City Road Upgrade, Northcott Drive and Kahibah Road

Submissions report

Roads and Maritime Services | May 2019

FIGURE 1.2
Key Features of the Proposal

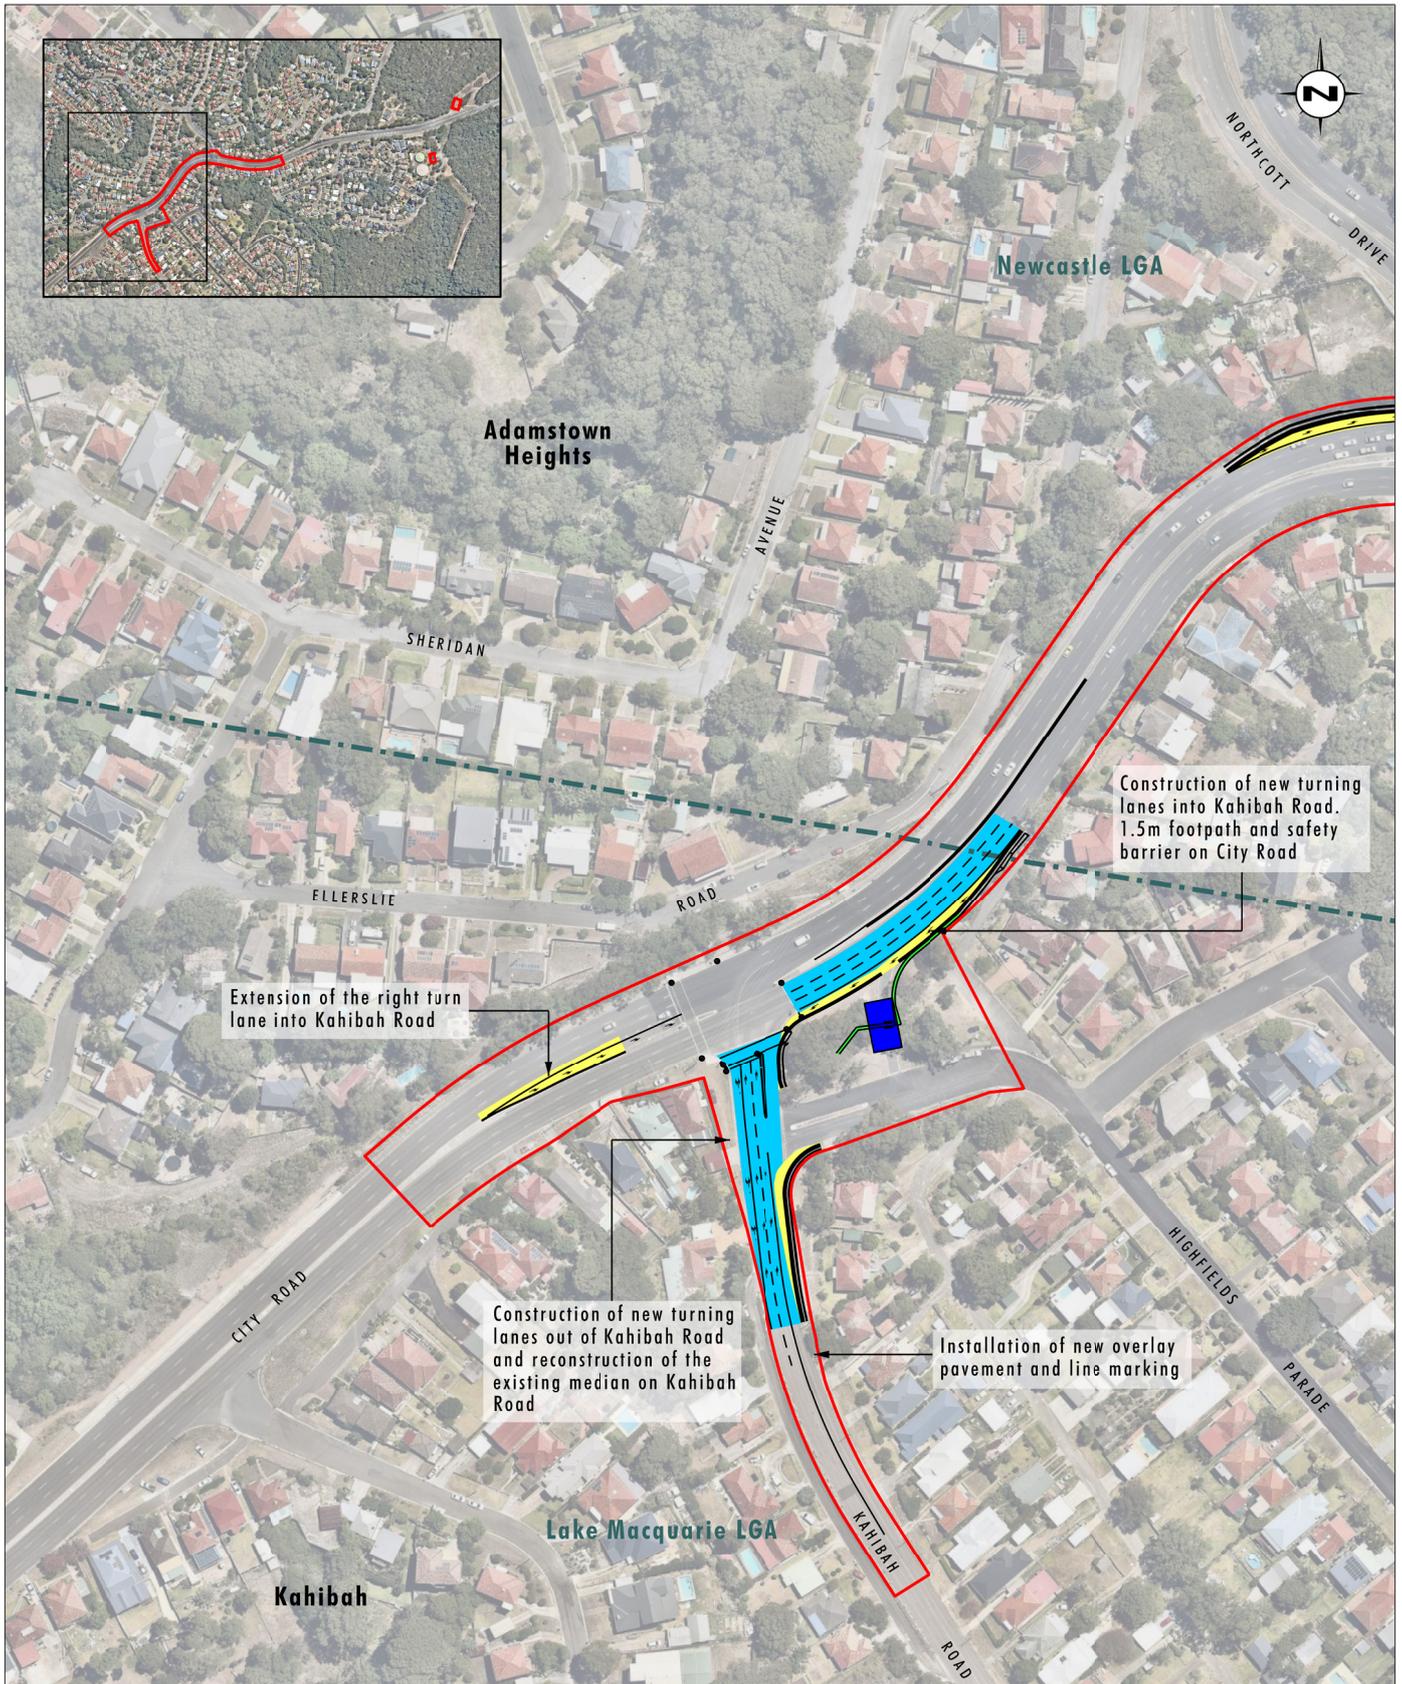
The proposal would involve the provision of a new pedestrian crossing across Northcott Drive and would upgrade the existing pedestrian crossing across City Road (near Northcott Drive) to meet Disability Standards for Accessible Public Transport 2002 (DSAPT) (refer to Figure 1.2).

FIGURE 3.1

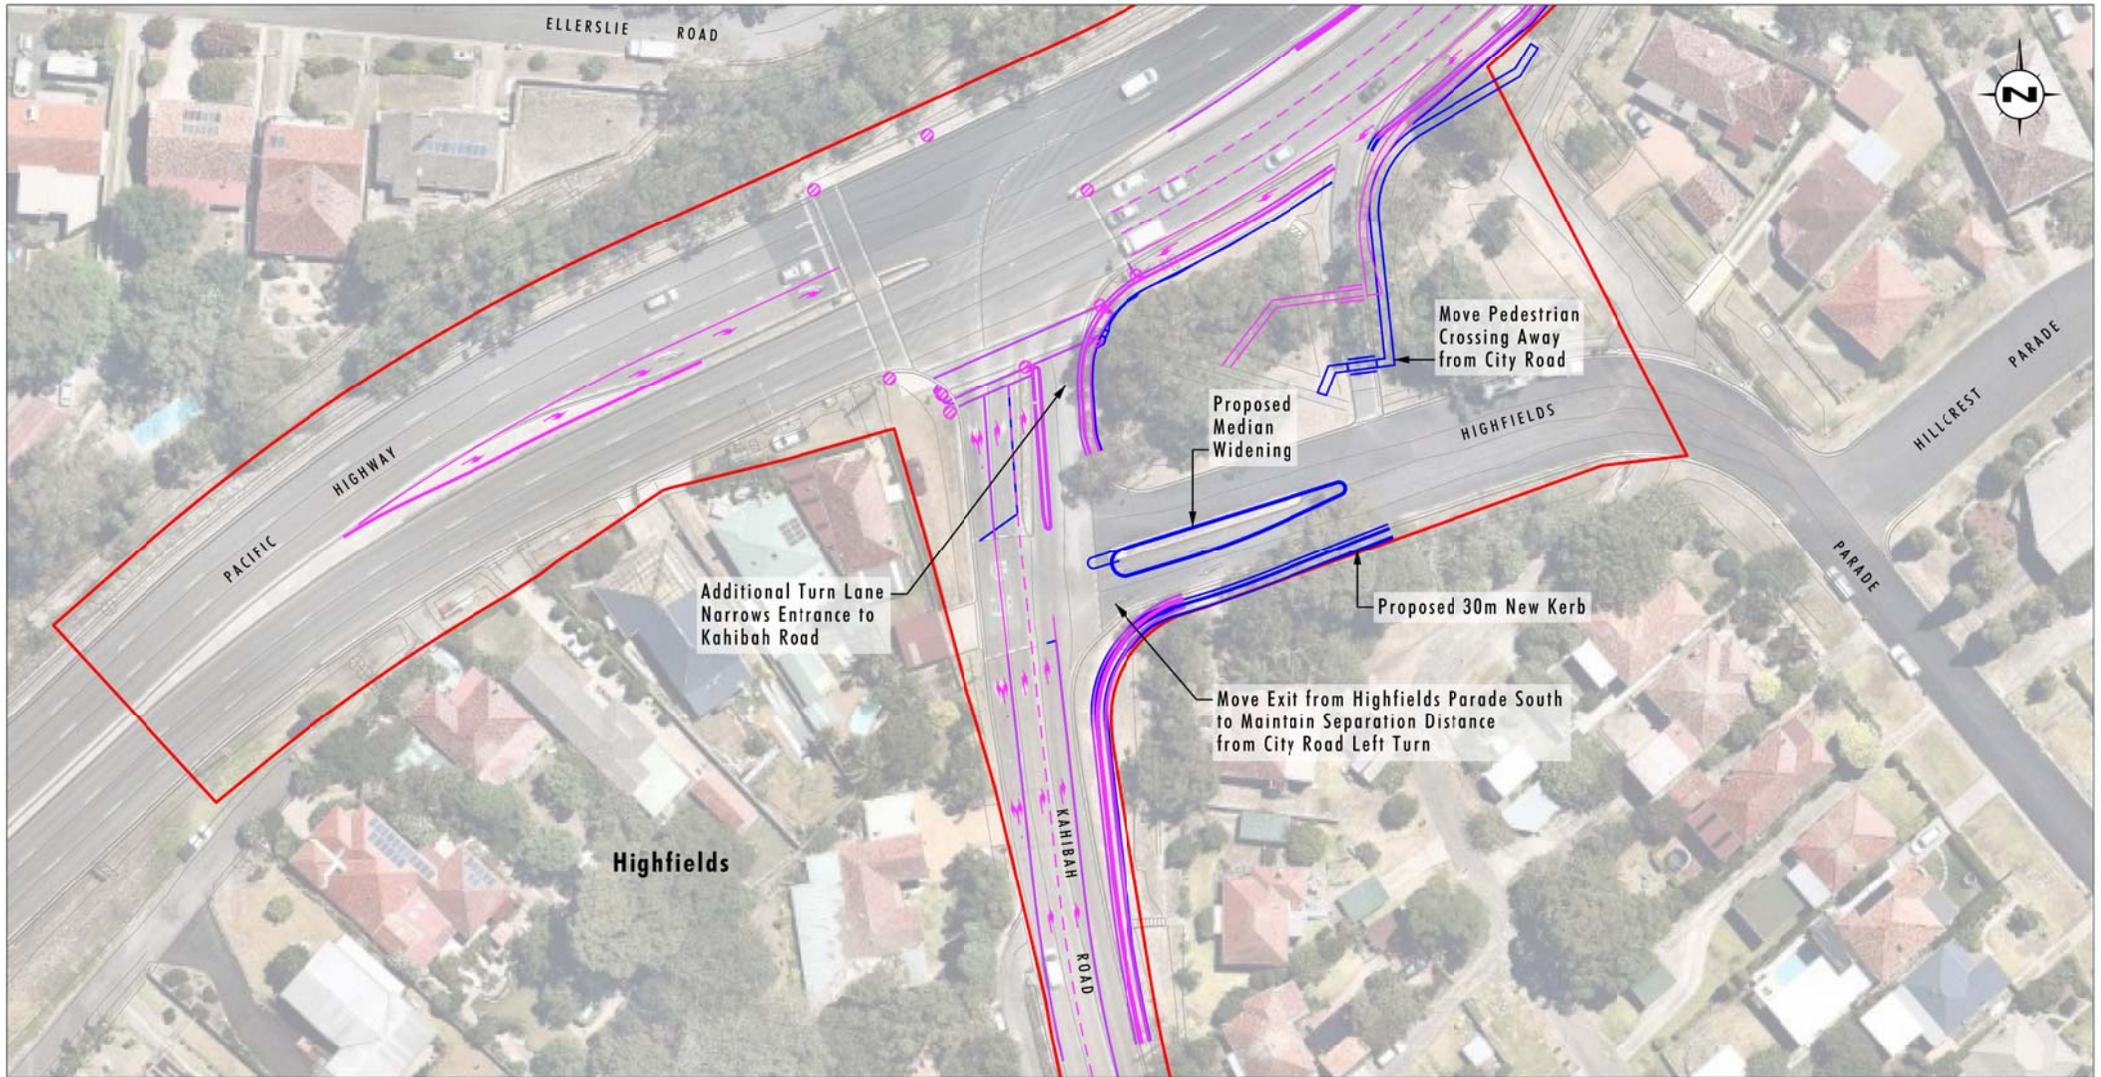
In order to maintain the current separation distance, Roads and Maritime is proposing to shift the exit out of Highfields Parade further south by widening the median in Highfields Parade and modifying the existing kerb on the southern side of Highfields Parade. An indicative revised layout design is provided in Figure 3.1.

In response to the submissions received about pedestrian facilities within the existing community parkland near Kahibah Road, Roads and Maritime has reviewed the concept design in order to address safety concerns. The proposed changes are outlined below and shown in Figure 3.1:

FIGURE 3.2

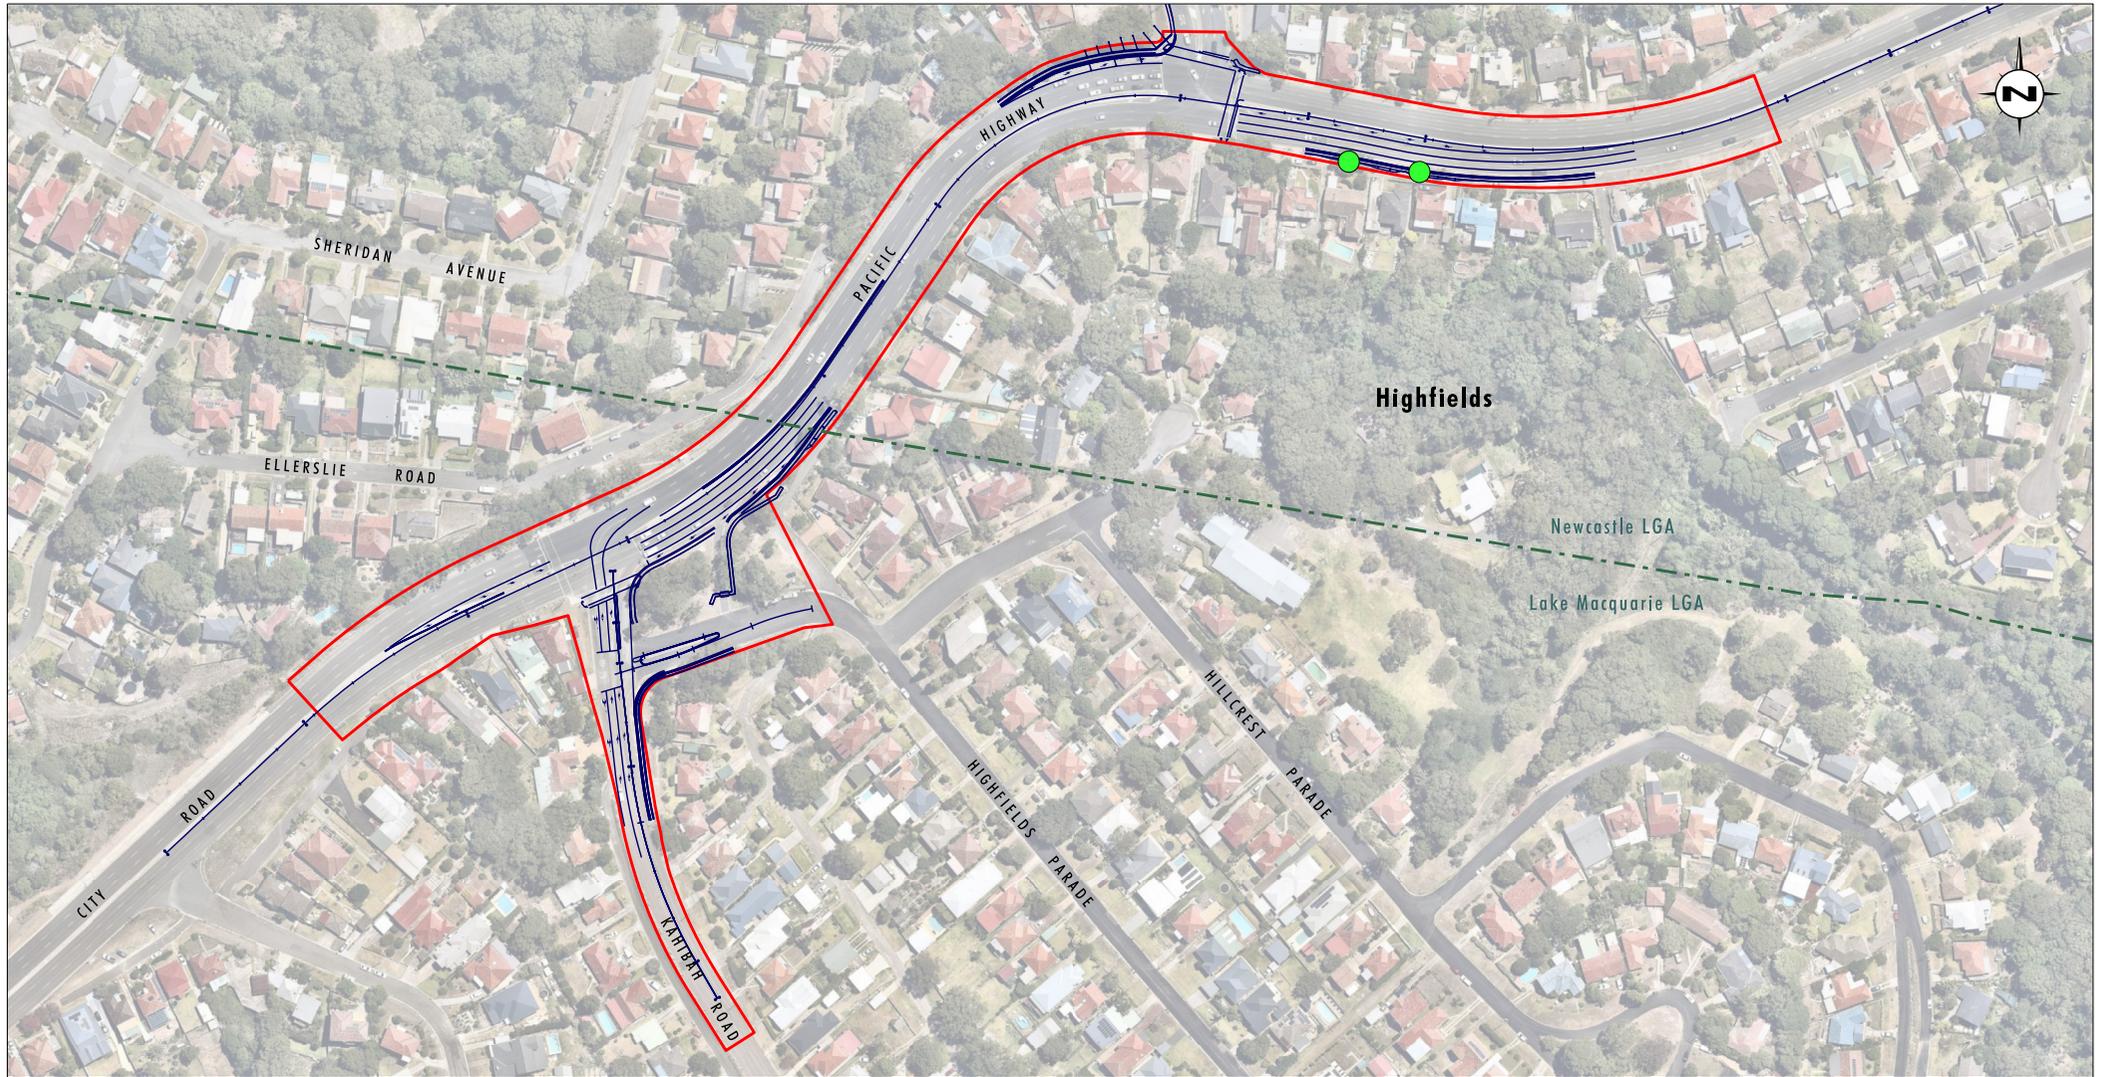
The additional area of vegetation (refer to Figure 3.2) to be removed includes planted exotic understorey species, two stiff bottlebrush (*Callistemon rigidus*) shrubs and two mature jacaranda trees (*Jacaranda*

As outlined in Section 4.2.3, the additional area of vegetation (refer to Figure 3.2) to be removed includes planted exotic understorey species, two stiff bottlebrush (*Callistemon rigidus*) shrubs and two mature jacaranda trees (*Jacaranda mimosifolia*) (Plates 4-1, 4-2, 4-3).
